SUBJECT: INFORMATION ON TEST CONDITIONS FOR AP600 TESTING PERFORMED  
AT THE SPES-2 AND OSU TEST FACILITIES

Attachment 1 to Westinghouse Letter NTD-94-4070

Information in support of Westinghouse Response to RAI 952.37 - RAI 952.41

Initial and Boundary Condition Data for AP600 Testing  
at the SPES-2 Test Facility

Figure 952.40-1  
AP600 OSU Test Facility  
Radial Power Distribution in Model Core

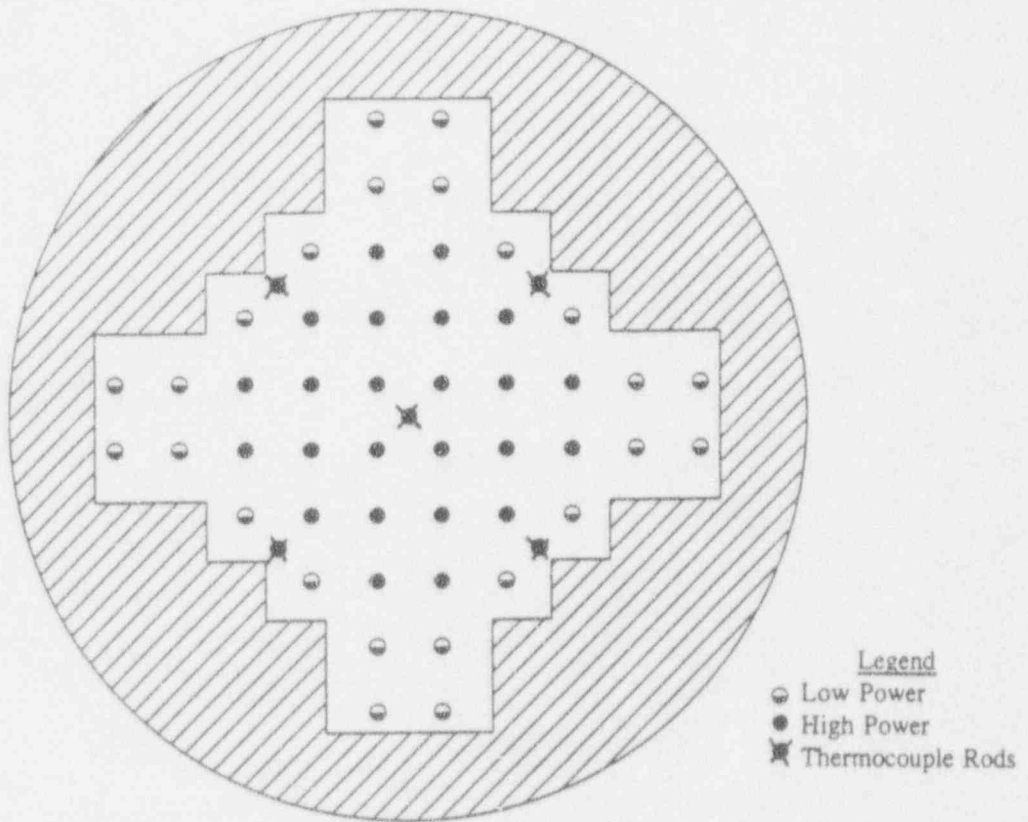
Provide the planned power to each radial zone of the core heater rods of the OSU/APEX facility. If specific measurements or design requirements have been made of the axial power profile, provide these values.

The OSU test facility simulated core region is comprised of 24 rods in the high power region and 24 rods in the low power region. Each rod has a heated length of 3 feet and a maximum power of 15 kw. The following additional information is provided:

- Table 952.40-1 AP600 OSU Test Facility Core Decay Power Simulation
- Table 952.40-2 AP600 OSU Test Facility Axial Power Fractions for 1/4 Length Scale Core
- Figure 952.40-1 AP600 OSU Test Facility Radial Power Distribution in Model Core
- Figure 952.40-2 AP600 OSU Test Facility Core Power Decay Simulation
- Figure 952.40-3 AP600 OSU Test Facility Axial Linear Power Profile (Normalized) for the Model Core

Figure 952.49-1  
Calculated Break Flow vs. Time for SPES-2 2 inch Cold Leg Break

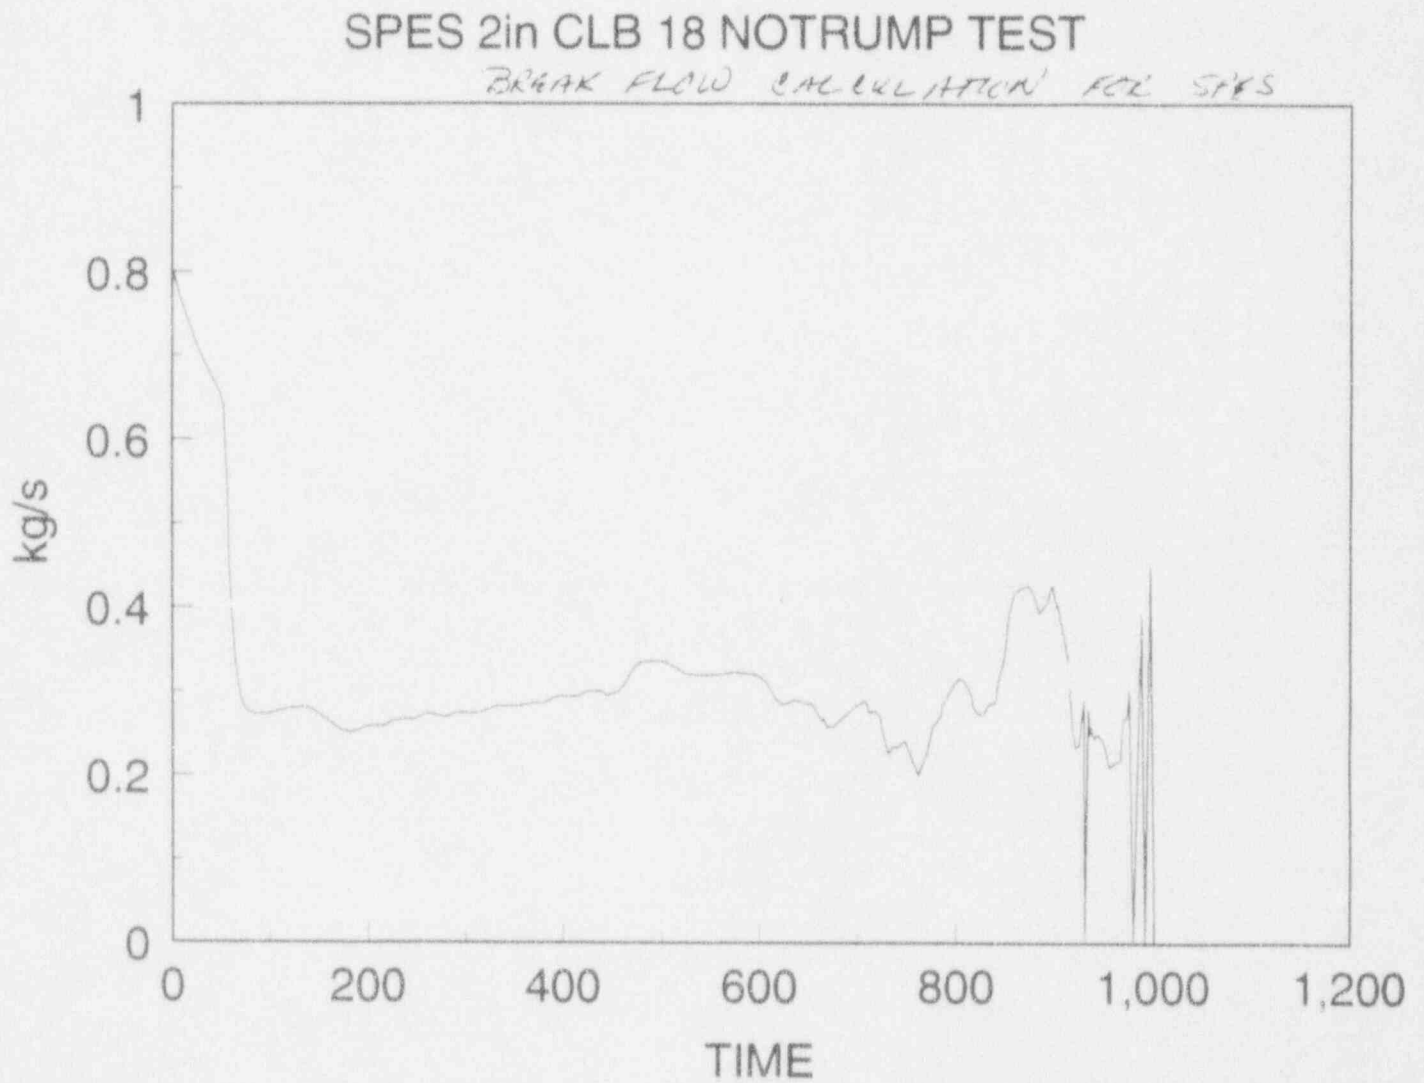
a.1. Target break mass flow at specified conditions.

Figure 952.49-1 provides the break flow for a SPES-2 "2 inch cold leg break" test as calculated by the NOTRUMP computer code. Figures 952.49-2 and 952.49-3 identify the the break spool piece configuration and location.

Figure 952.49-4  
SPES-2 Break Simulation for "2-inch" Break

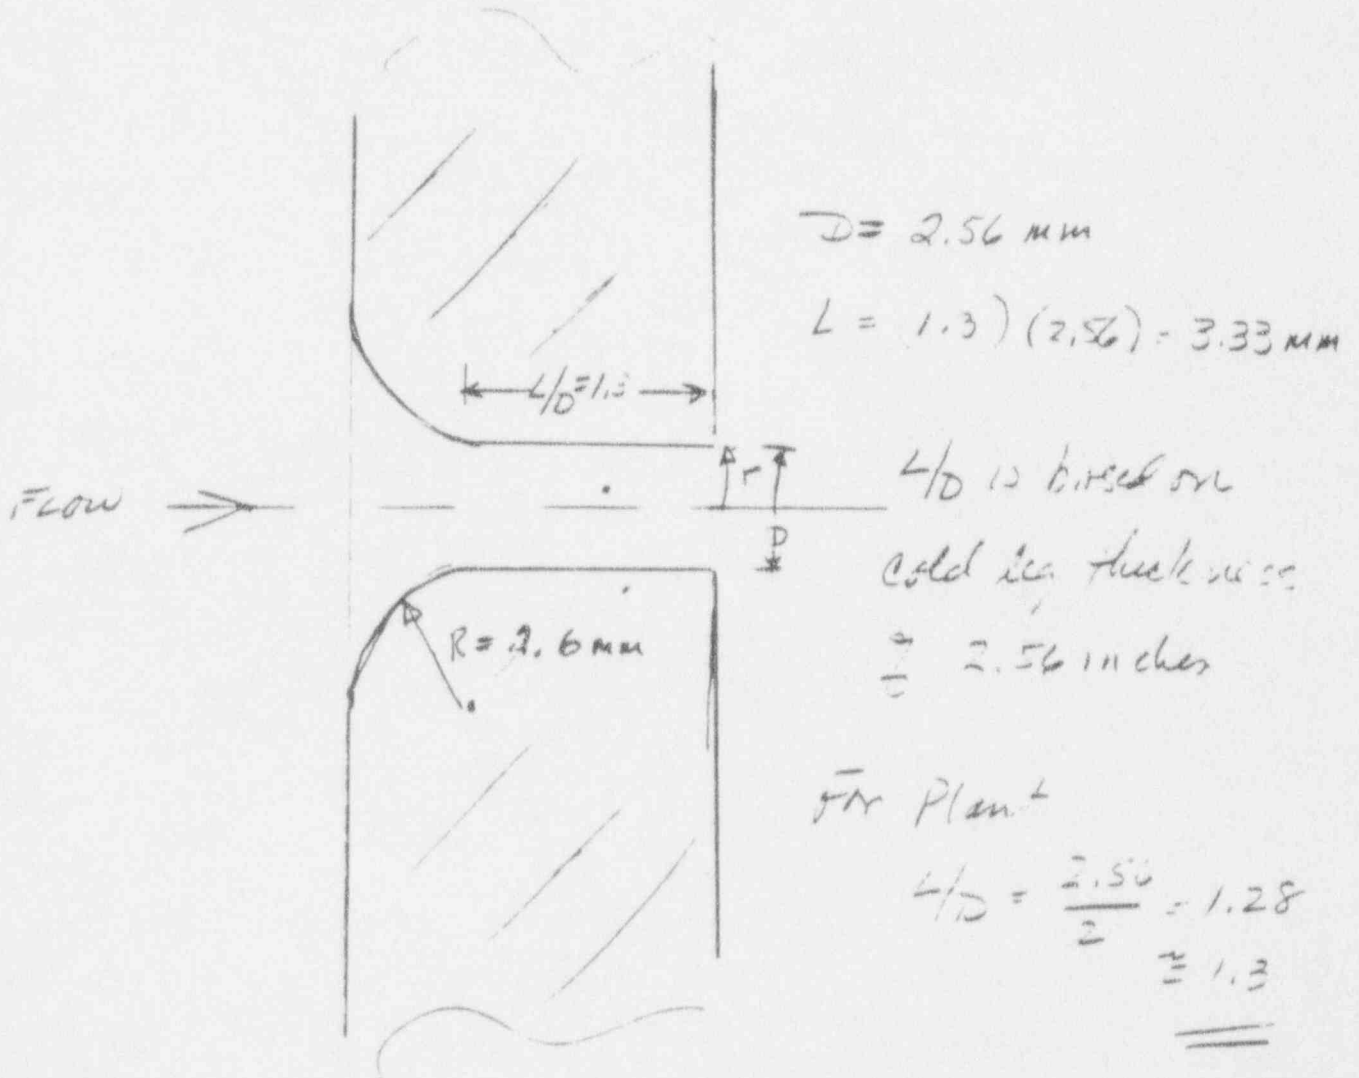
a.3. Break length-to-diameter ratio.

a.4. Break geometry, e.g., beveled orifice, etc.

The break L/D ratio has been based on the wall thickness of the AP600 cold leg piping, which is 2.56 inches. For example, a "2-inch" break would have an L/D of approximately 1.3 (see Figure 952.49-4). This criteria will not apply to the DVI and CL to CMT balance line DEG breaks since they are full guillotine breaks of the piping..

The break orifice will use a rounded inlet with a radius equal to the break diameter. The L/D portion of the break will start after the inlet rounding and where the flow area is a constant. Figure 952.49-4 illustrates the break geometry.

Figure 952.49-5  
SPES-2 Steam Generator Instrumentation

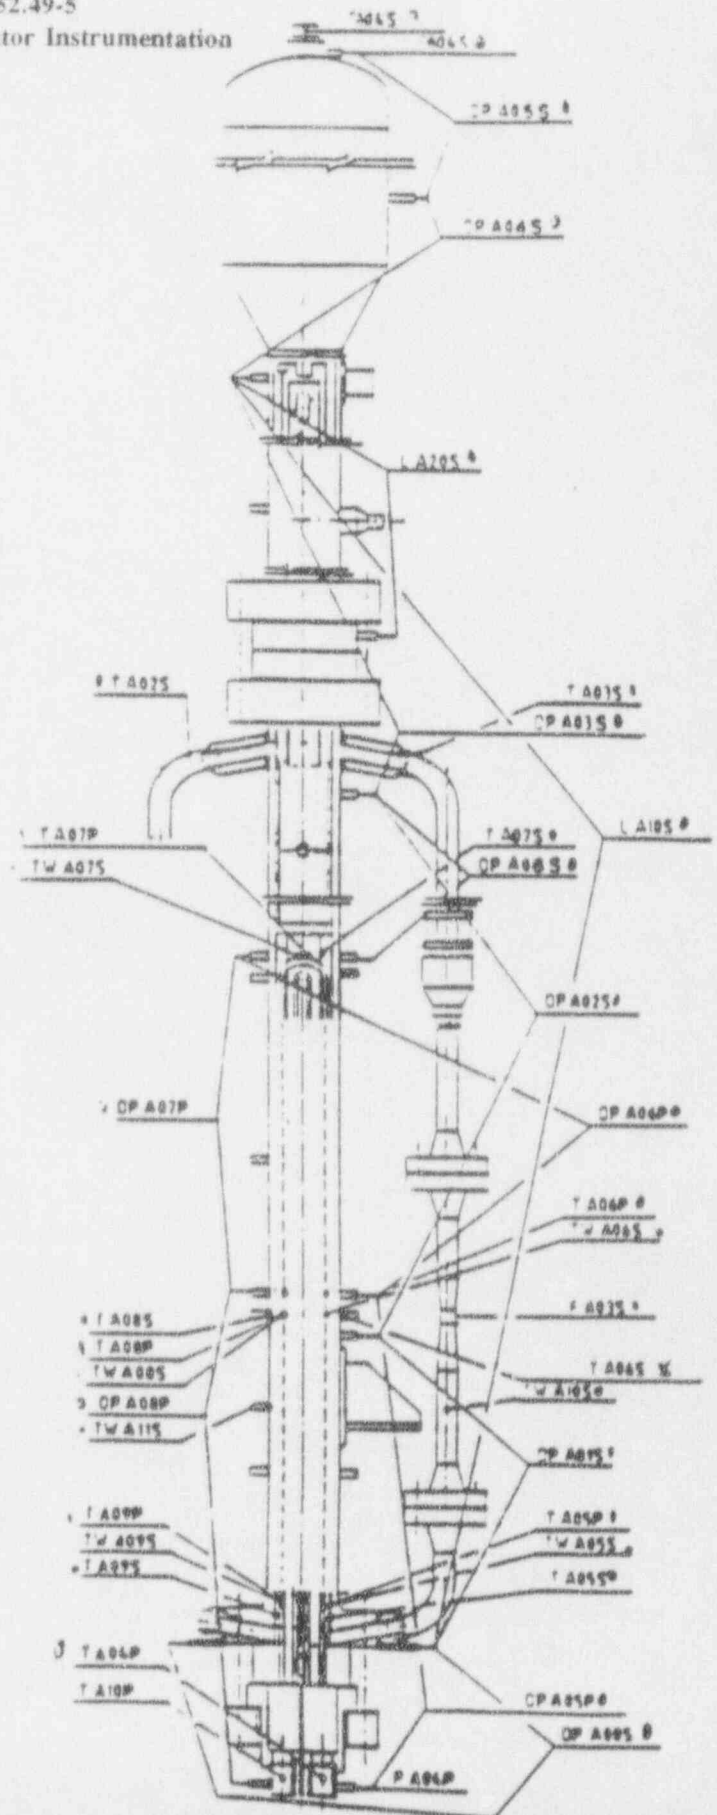
d.4. Secondary water level or mass level?

The initial steam generator narrow range water level is identified in Table 952.49-2. This initial level corresponds to a reference elevation of 12.8 meters (see Figure 952.49-5, SPES-2 SG Measurement Arrangement). At this level, the secondary water mass is approximately 160 kg per SG.
